U.S. Department
of Transportation
**Federal Highway
Administration**

We have assigned your request for interpretation the following official ruling number and title: "6-225 (I) – Use of ONE LANE ROAD AHEAD Signs in TTC Zones." Please refer to this official ruling number in any future correspondence.

In accordance with the guidelines set forth in the Manual of Uniform Traffic Control Devices (MUTCD), the California Department of Transportation (Caltrans) formally requests interpretation of the application and operation of the ONE LANE ROAD Sign (W20-4) as stated in Part 6 of the MUTCD. Please provide clarification on this safety oriented issue to ensure continued compliance.

MUTCD Section 6F.20 ONE LANE ROAD Sign (W20-4)

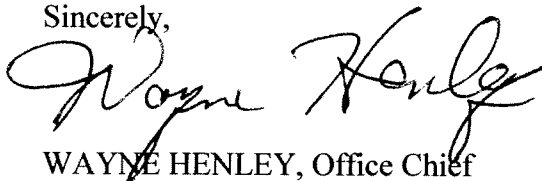
In California, for TA 10 situation, there were only 3 sets of signs (without the W20-4 sign) until the recent adoption of MUTCD in California. In TA 10, since the flagger is present to direct traffic and the motorist needs to pay attention to the flagger regardless of the closure and activity, what purpose does the W20-4 sign serve? The extra employee exposure is not worth the benefit of an additional sign. In fact, having to place and retrieve the extra signs on foot in proximity to moving traffic becomes detrimental to employee safety. After all, how many years have we operated successfully with the three sign package? The W20-4 sign may be appropriate in situations when flaggers are not utilized. This issue is being raised as part of a safety task force in response to Caltrans recent worker fatalities to enhance worker safety by reducing the amount of time workers are exposed to moving traffic.

There are also some reported cases of motorist confusion as the W20-4 sign, by identifying the condition downstream, leads motorists to start reacting and planning for it rather than paying attention to the flagger regardless of the downstream condition. It confuses motorists as they are not sure as to which lane they should be in when approaching and observing the W20-4 sign. What is the benefit of the W20-4 sign as a fourth sign, where three worked as well before?

The TA 18 shows a lane closure situation on a minor street where speeds and traffic volumes are low and where the drivers can see the roadway beyond the one-lane section such that they can determine for themselves whether it is safe to proceed. This TA does not show any W20-4 signs

and the clear inference is that the use of W20-4 signs in this situation is neither recommended nor required. (Note 3 in TA 18 says if speeds, traffic volumes, or the length of the one-lane section is such that traffic cannot effectively self-regulate, then the flaggers and traffic control devices, including the W20-4 signs, shown in TA 10 shall be used).
